LIGO- LIGO-T060109-00-D

Preliminary Weld Tests, mid May 2006

Stefano Molesti, Marcello Berchiolli, Yumei Huang, Riccardo DeSalvo

Figure 2: Welds of sample 2
Weld 3 TIG, Ar, sample pre-heated by MIG
Weld 4 MIG, He-Ar mix, cold sample

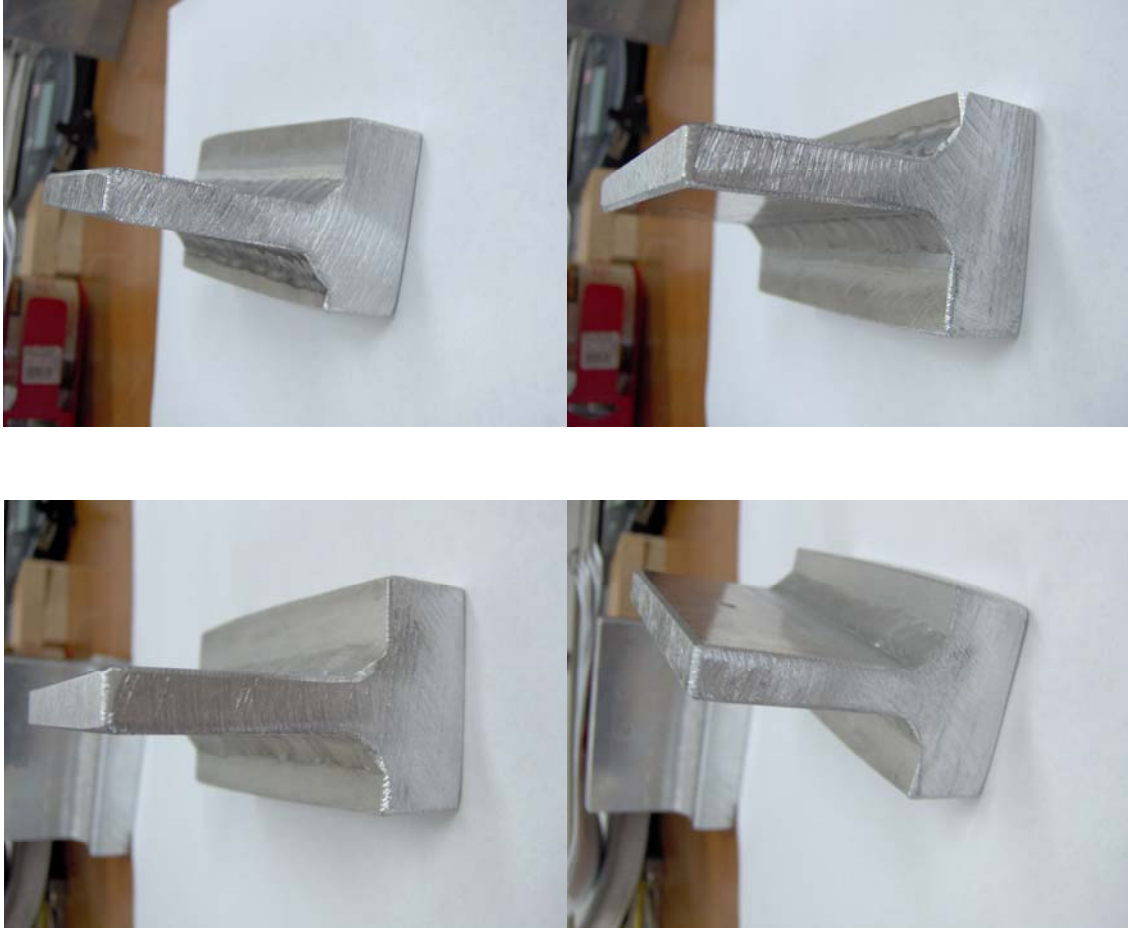
The T-welds labeled 1-2 and 3-4 (figure 1,2 and 3) appear at first sight to be quite good samples. The welds in the saw cuts appear compact and uniform.

Weld 1 looks the best, quite uniform and little waving, weld 3 and 4 are similar between themselves, the only problem is what appear as a bubble or small inclusion in weld 3 right under the 3 label (see figure 2).

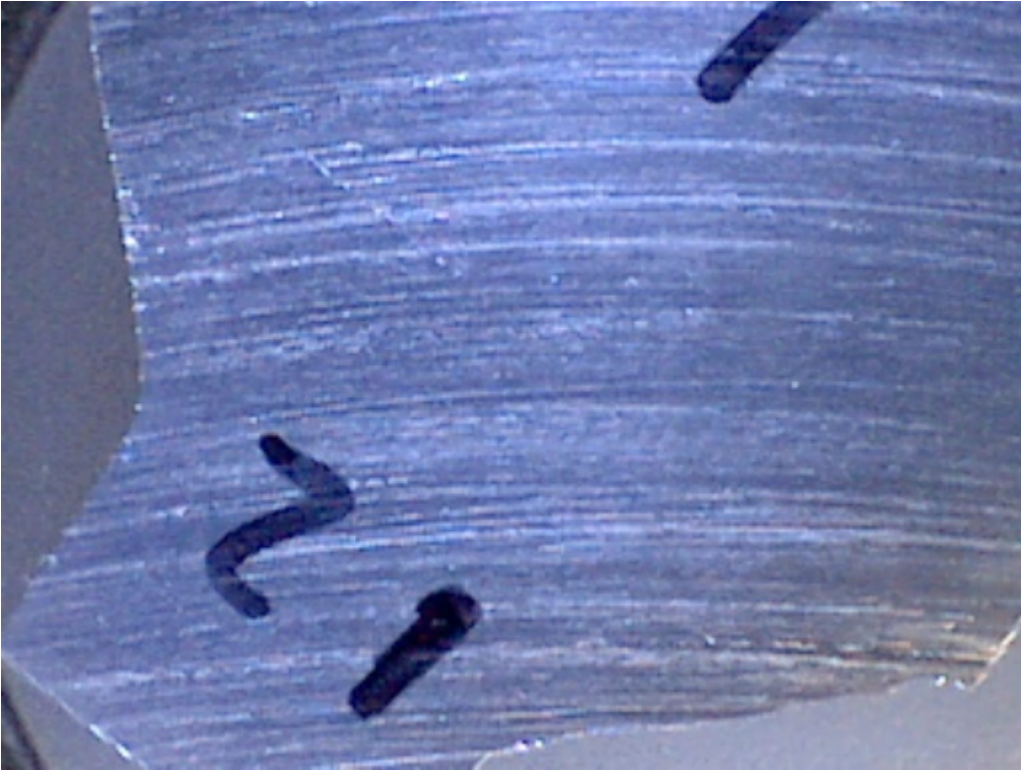
The problem comes from the hairline cracks visible in many, but not all sections.

The crack marks the boundary between the two parts welded together, and indicates that full penetration welding was not achieved. The lack of hairline crack in some welds indicated that occasionally full weld was achieved.

Unfortunately these long cracks have little chance of being completely isolated inside the aluminum welded body and would absorb machining oils and then produce virtual leaks by out-gassing in the vacuum.

Likely if the contact surface had been reduced drastically by heavy chamfering, full depth welding would have probably achieved.

The good quality of the weld fillet shows that full penetration welding can likely be achieved with this welding technique and different preparation of parts to be welded.
